ROOT CREEK
BOLIVAR, NEW YORK

(X) Final Environmental Statement

ROOT CREEK
BOLIVAR, NEW YORK
LOCAL FLOOD PROTECTION PROJECT
FINAL
ENVIRONMENTAL STATEMENT

GENERAL PLAN

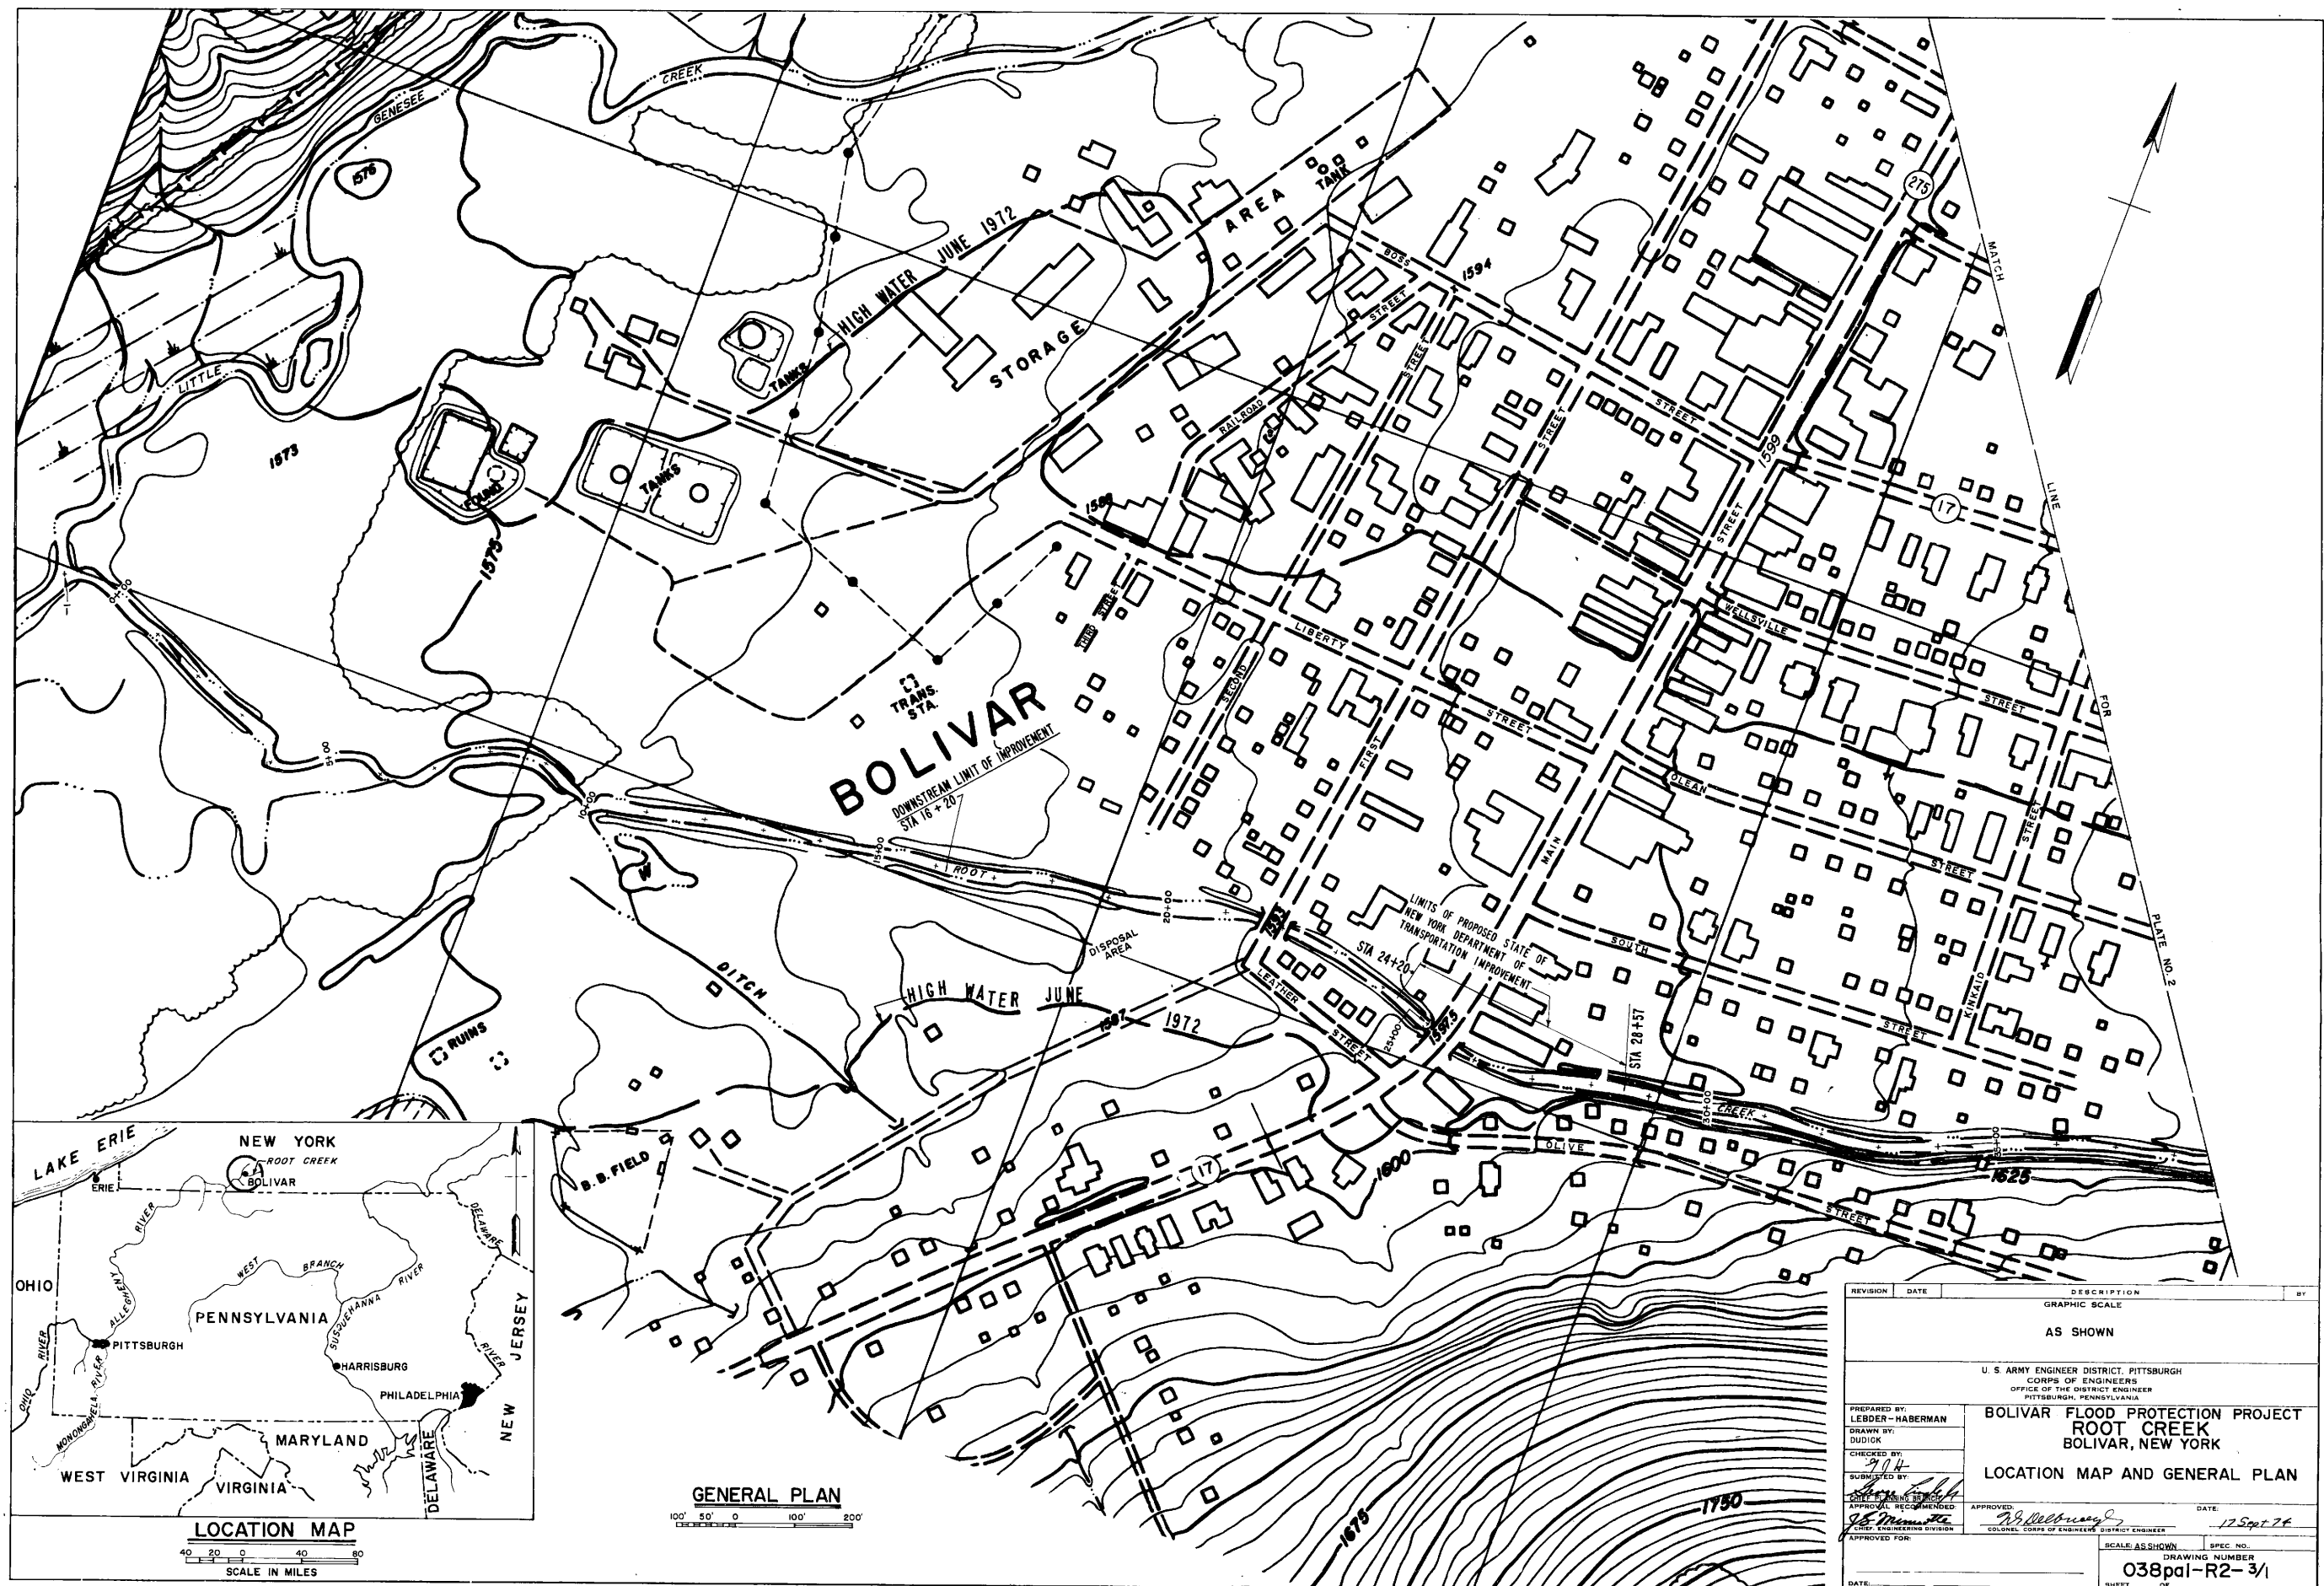
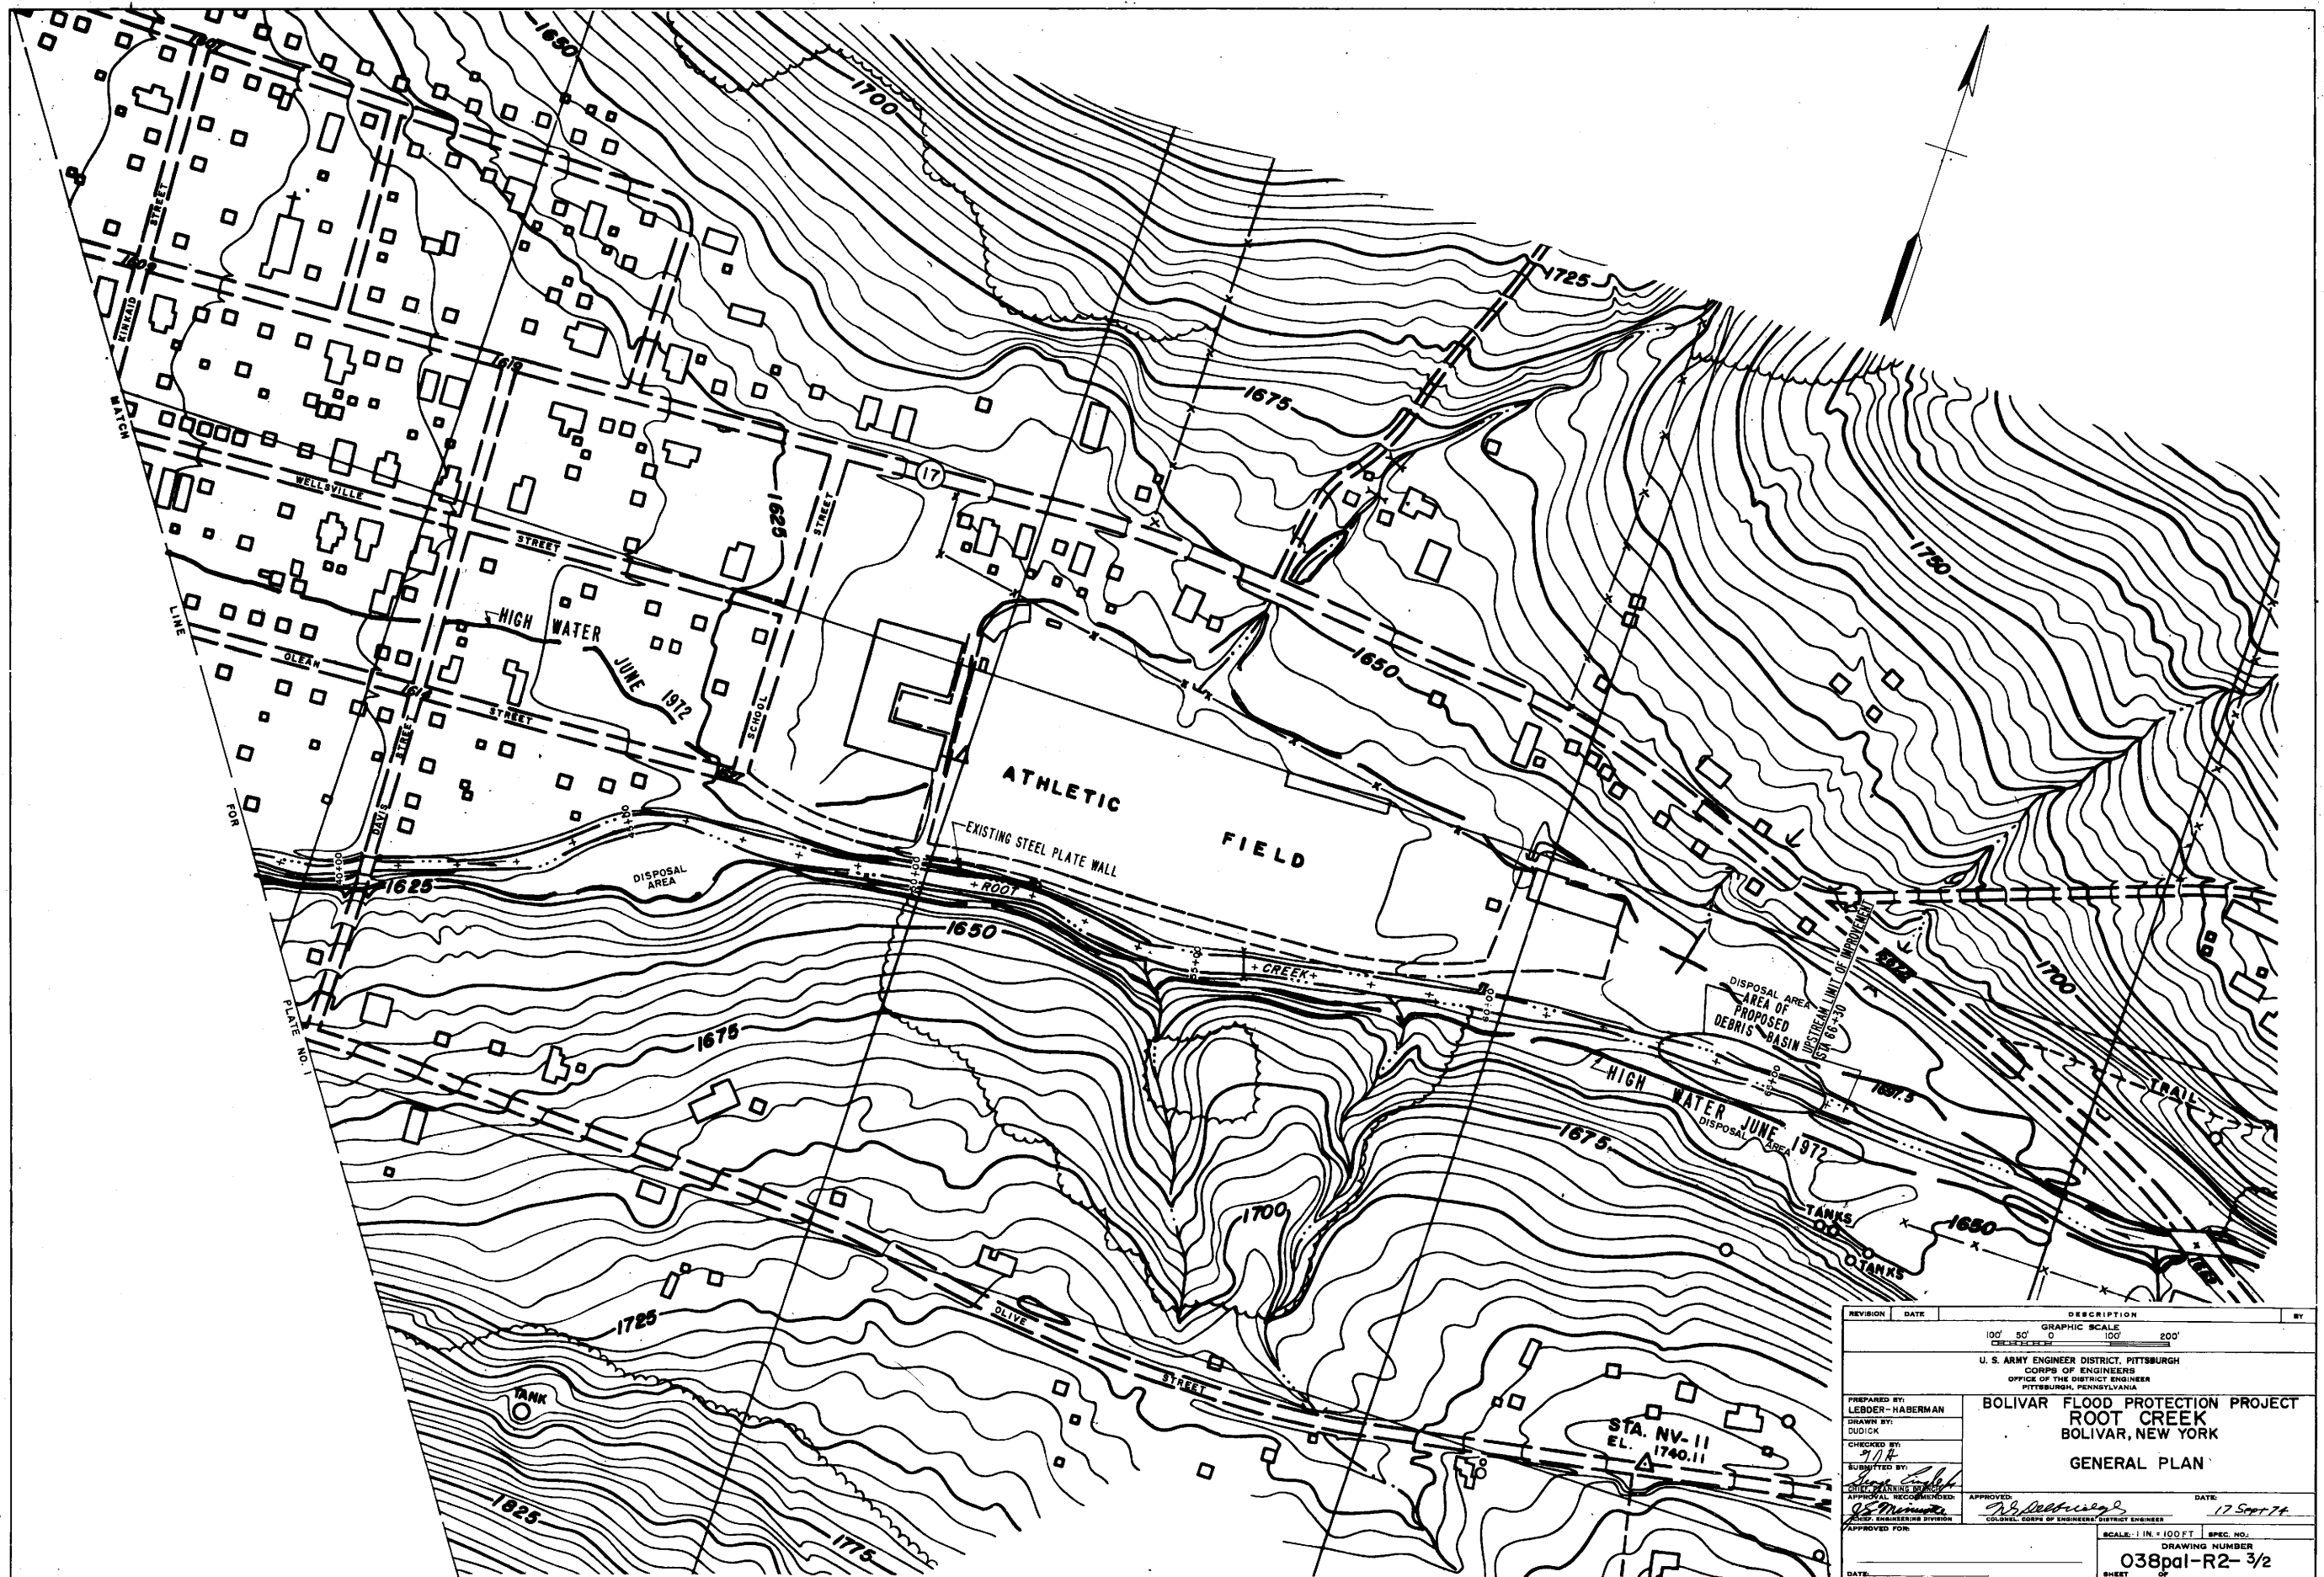
d. Comment: From Detailed Plan Plates No. 1 and 2, it appears as though disposal areas are within the natural 1972 high water flood plain. If these locations could be used as flood storage areas, some of the need for channel construction could possibly be negated.

Response: The volume of the locations proposed for disposal of excavated material, even though situated on the flood plain within the limits of the June 1972 flood, if utilized to store flood waters, would have an insignificant effect on reducing flood flow elevations within the damage area.
